RISO INC. TECHNICAL INFORMATION BULLETIN

Subject: Separator Spring; Release Lever | Bulletin No: 37

Subject: Factory Modification to Separator Springs (Front and Rear), RG 3500UL Serial #90440451 RG 2500 Serial #90470901 and above are factory modified.

PANEL SIDE

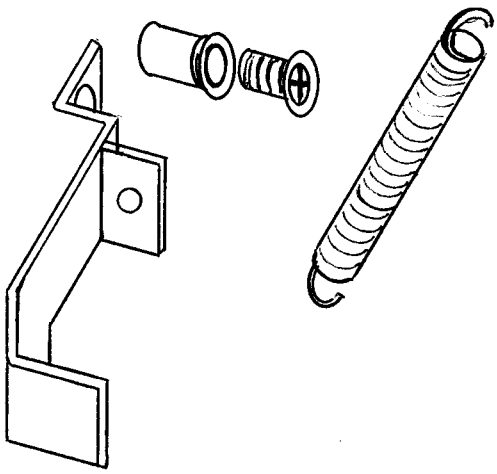
Purpose: Both spring tensions are changed to insure a positive pivot action to the seperator.

Spring: Release Lever 11
Old Part #007-13121-Black
New Part #007-13126-Silver

If replacing either of these springs in machines prior to these serial numbers, both springs have to be replaced as a set.
Please refer to parts manual pg11-2 item 9 and 11 - 29 item 11 for location identification.

DRIVE SIDE

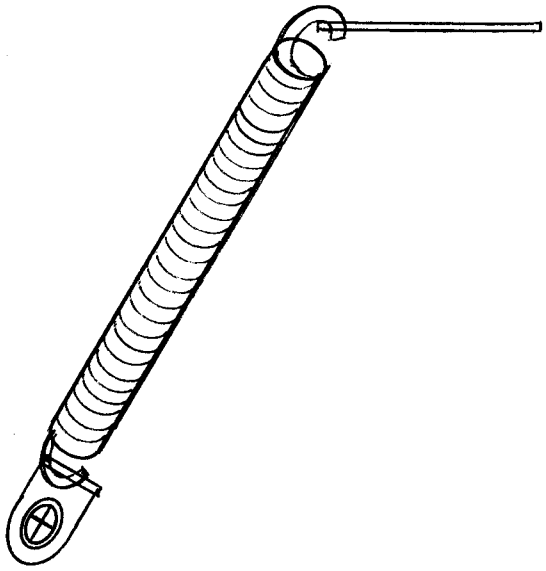
Spring: Hook
Old Part #002-13352-38mm
New Part #002-15329-48mm Stronger Tension
